ND NORSK DATA	ENGINEERING CHANGE ORDER		PAGE 1 OF 4.
			ECO NO.: 100-782
VALID FOR.	PART NOS. : 324909 VERSIONS : AA NAME : MAXSON DISKBOARD PRINT NOS.: 5909 ND NOS. : --		
NEW VERSION	PART NOS. : 324909 VERSIONS : BA NAME : MAXSON DISKBOARD		
SYMPTOMS	<u>FATAL:</u>  Overwriting on SCSI-devices or transfer error.		
COMPO- NENTS  Resistor	REMOVE:	INSERT:  2 pc. 330 ohm (p/n 503020)	
VALIDITY	X      EQUIPMENT IN PRODUCTION  X      FUTURE PRODUCTION  * *    FIELD ACTION		
RESPONS- IBILITY	APPROVED BY: LB _____ DATE:            910620 _____	REVISION:            _____ ISSUED BY:            _____ DATE:                _____ _____

ND NORSK DATA	ENGINEERING CHANGE ORDER	PAGE 2 OF 4.
PART NO.: 324909 AA > BA		ECO NO.: 100-782
ISSUED	DATE: 910612	BY (INITIALS): AMA

ID NO: 324989 AA PRINT: 5989	SHEET 4 OF 6
MAXSON DISKBOARD SCSI TO STR./DISKS C_PLUGS	DESIGN: ERIK DRAWN: ERIK DATE: 1 861211
REVI:

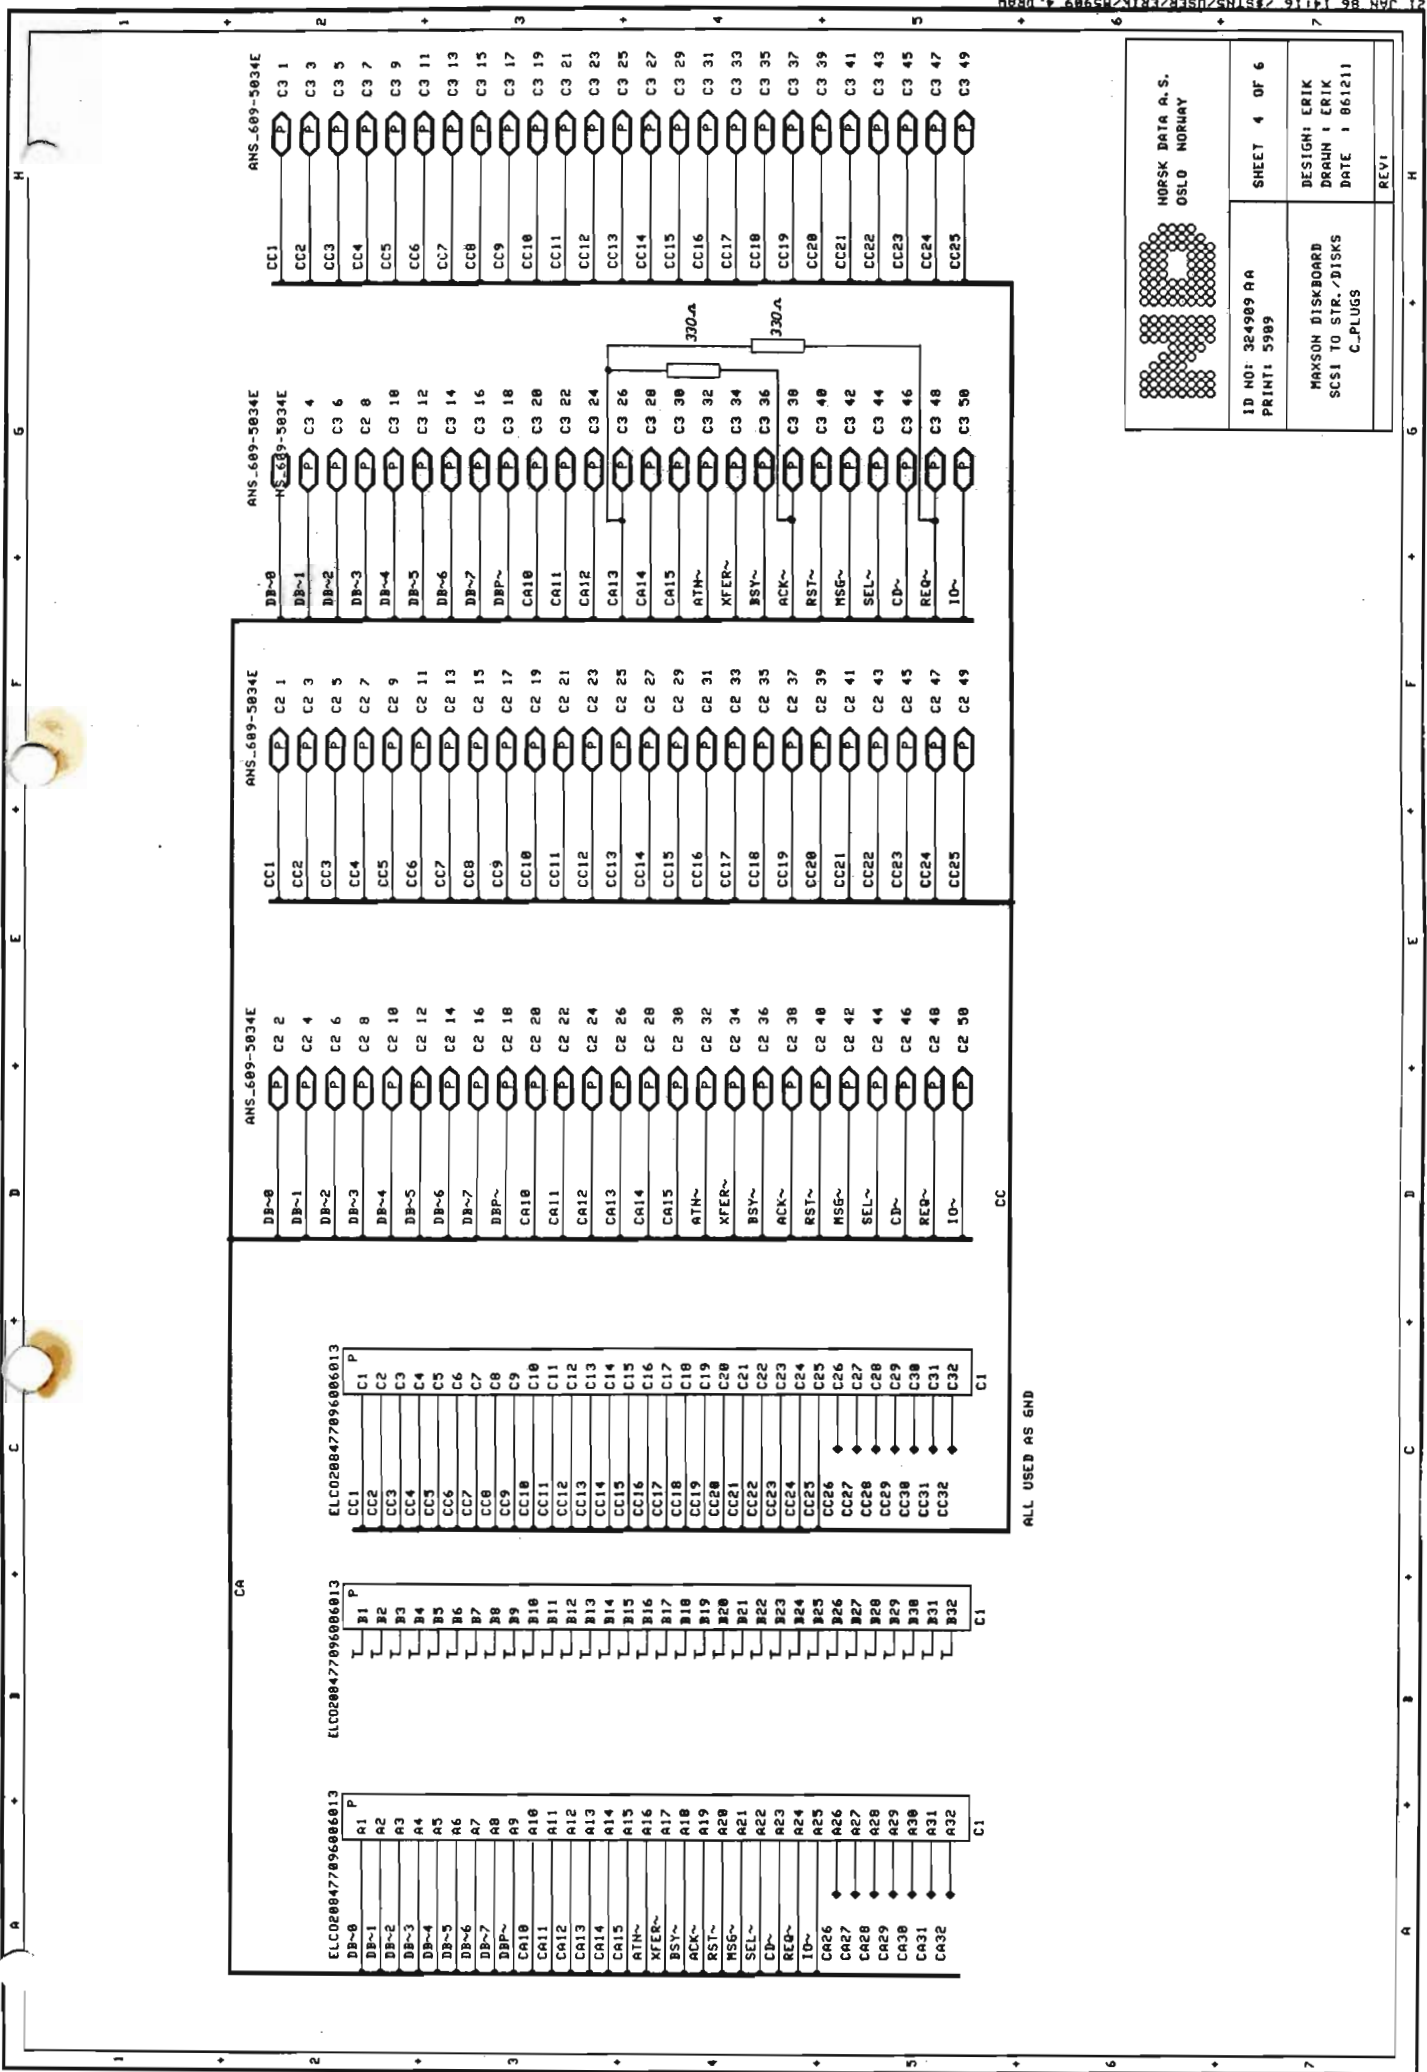
Insert 1 pc. 330 ohm resistor C3/38 - C3/26 (REQ-0 - TERMPWR)  
 Insert 1 pc. 330 ohm resistor C3/48 - C3/26 (ACK-0 - TERMPWR)
